ASSEMBLY ORDINANCE 2026-33

UPDATE TO TITLE 23

BY DEVELOPMENT SERVICES DEPARTMENT

23.10.104.15 Mobile food units.

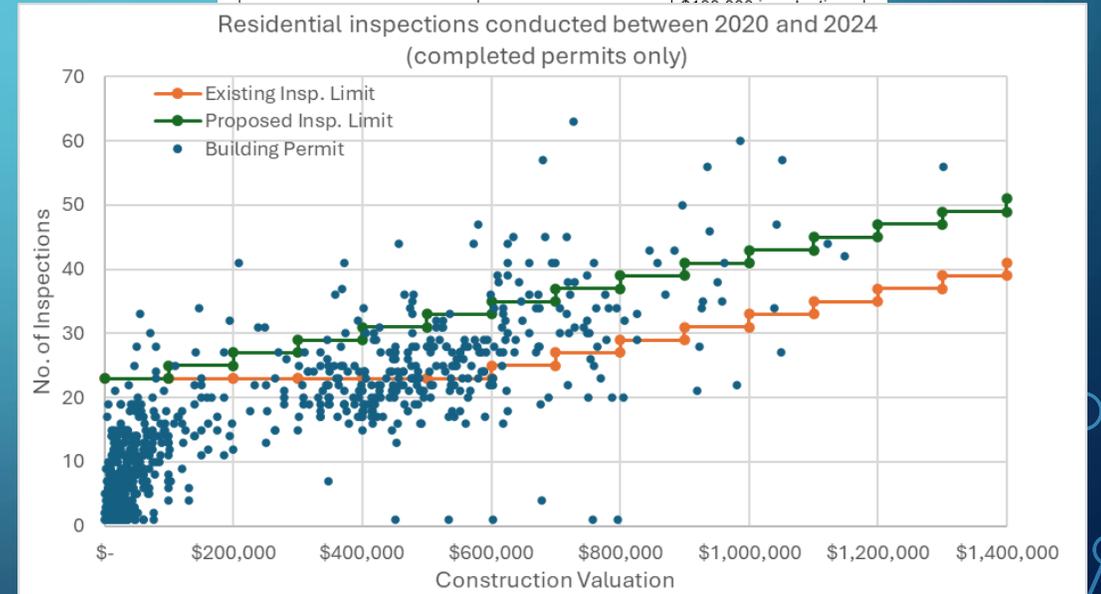
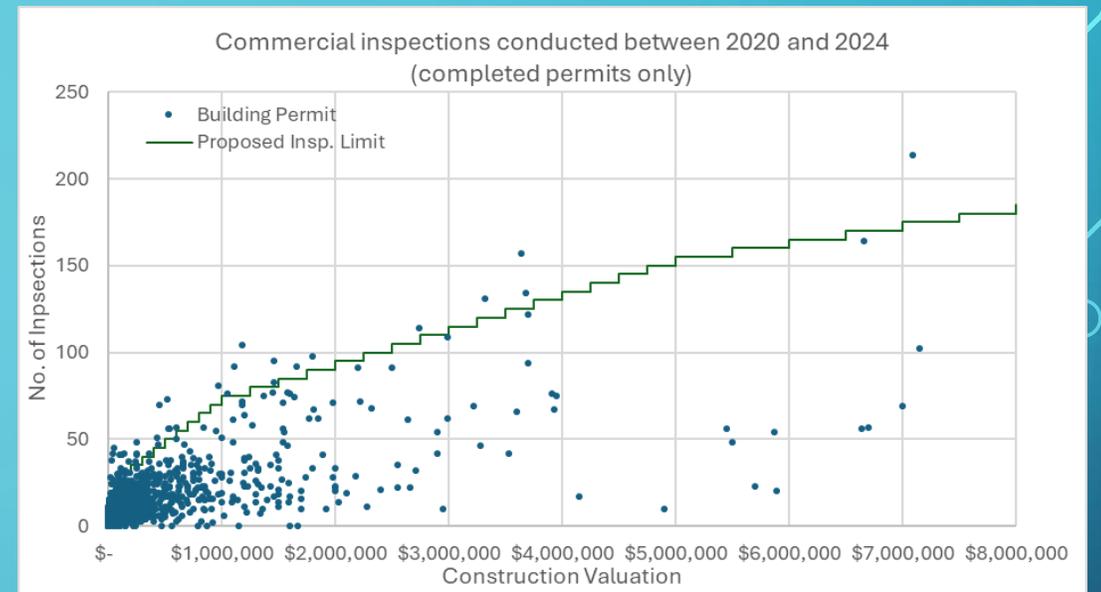
- 23.10.104.15 Mobile food units.
- 23.10.104.16 Shelter units located in allowed...

A. Mobile food units, including coffee carts and coffee huts, (hereafter within this section referred to as units) must obtain a building permit but are exempt from building plan review and building inspections except as required by this section under the following restrictions and requirements:

1. The unit shall not exceed 8 feet 6 inches in width, 48 feet in length or 15 feet in height, including overhangs.
2. The unit shall be readily moveable and one of the following:
 - a. Currently titled and licensed by the State of Alaska as a motor vehicle or a trailer having a tow hitch, chassis, axles, wheels and trailer lamps and reflectors in compliance with AMC chapter 9.44.
 - b. A pushcart as defined in AMC 16.60.050 and that satisfies the requirements of AMC 16.60.230F.
 - c. A factory built, readily moveable, intermodal shipping container repurposed to function as a mobile food unit which can be lifted or dragged onto a trailer or vehicle within one calendar day for transport.

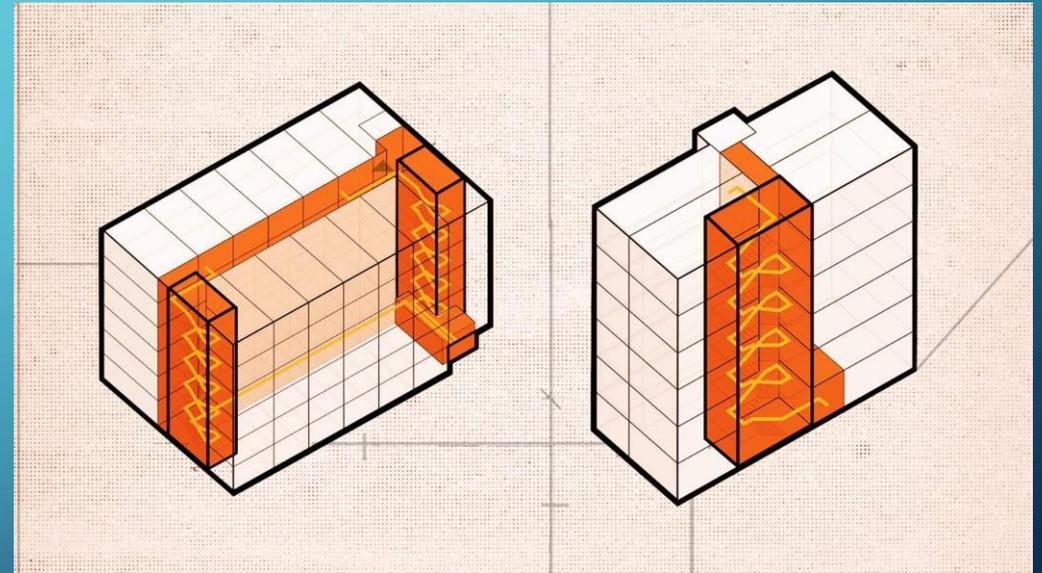
- 23.15.420.12 Single exit buildings...
 - Increases number of stories from 3 to 6.
 - Exception only sought within the BSSA due to the Insurance Services Office (ISO) class 1 fire department, plan review, and inspection requirements.
 - Currently seeking state approval through “Request for Modification” process, changes to be expected.

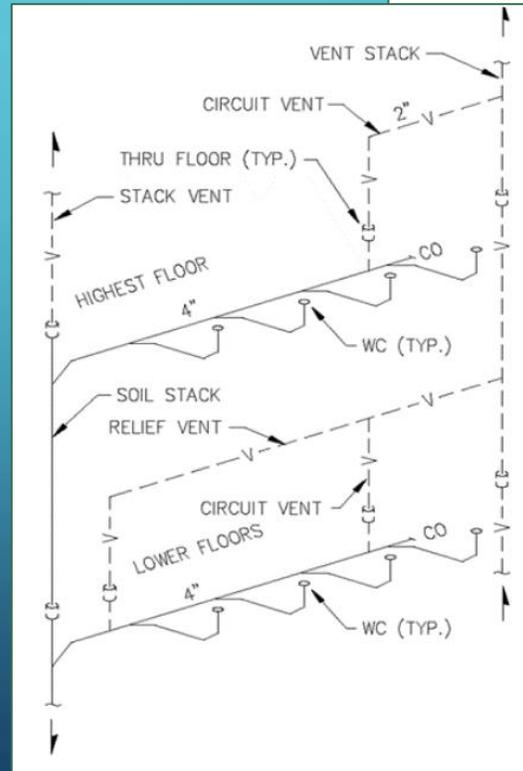
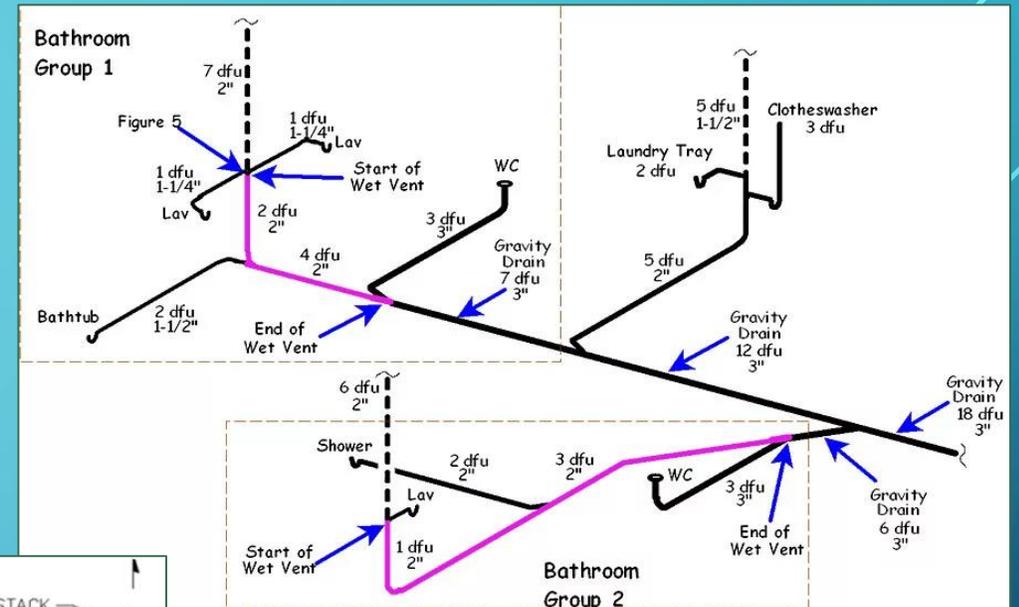
- 23.25.908.2 Horizontal wet venting for bathroom groups
 - Approvable in field
- 23.25.911.0 Circuit venting
 - Approvable with diagram and review

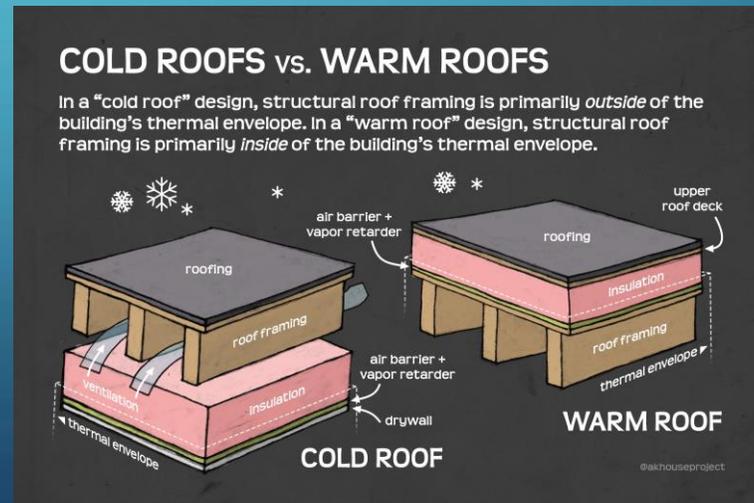
- 23.65.304.4 Additional permit requirements for reroofing
 - 2018 code cycle adopted a policy on requiring reroofs for increasing R-value
 - Subsequent AO changed to only require on buildings from 1970 or earlier
 - Reverting back to previous language without age limit

1. ~~For buildings constructed prior to 1970, in~~ existing non-snow-drift areas, if the R value of the existing assembly is less than R-30 and the new system will increase the R value by more than 30 percent, an engineer's report is required to verify that the existing framing is sufficient for a 40-psf snow load (allowable).
Exception: Existing cold ventilated roofs.
2. ~~For buildings constructed prior to 1970, in~~ existing snow-drift areas, if the assembly increases the R value 30 percent or more, an engineer's report is required verifying that the existing framing is sufficient for 40-psf snow load plus drift (allowable).
Exception: Existing cold ventilated roofs.
3. Where unlisted mechanical fasteners are used, capacities based on testing shall use the following minimum factors of safety: Fasteners in wood (4), Fasteners in metal deck (3).

23.75.2.7.6.2 Location of Machinery Spaces and Control Spaces.

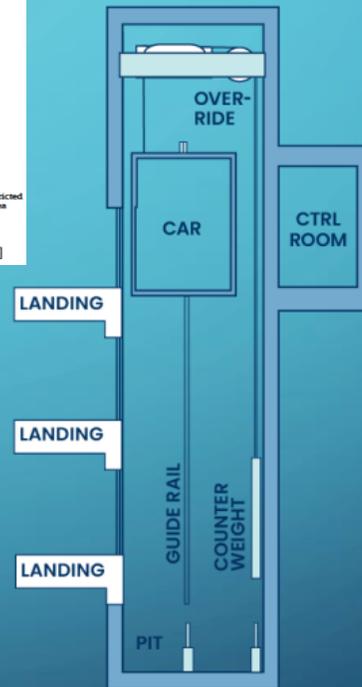
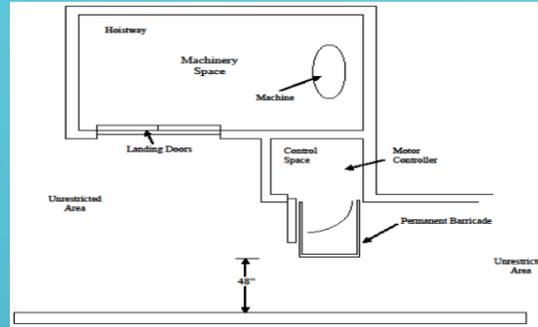
- 23.75.2.7.6.2 Location of machinery spaces and control spaces
 - Machine-room-less elevators (MRLs) typically put the control space inside the elevator shaft
 - Amendment won't allow it in the shaft without being able to access from outside
 - Has support of the International Union of Elevator Constructors Local 19

2.7.6.2 Location of machinery spaces and control spaces. Machinery spaces may be located inside or outside the hoistway. Control spaces are not permitted inside the hoistway unless it can be accessed for service from outside the hoistway. Service includes maintenance, repair, and replacement activities for all equipment and components within the control space.]

Exception: Control spaces may be located and accessed within a walk-in pit.
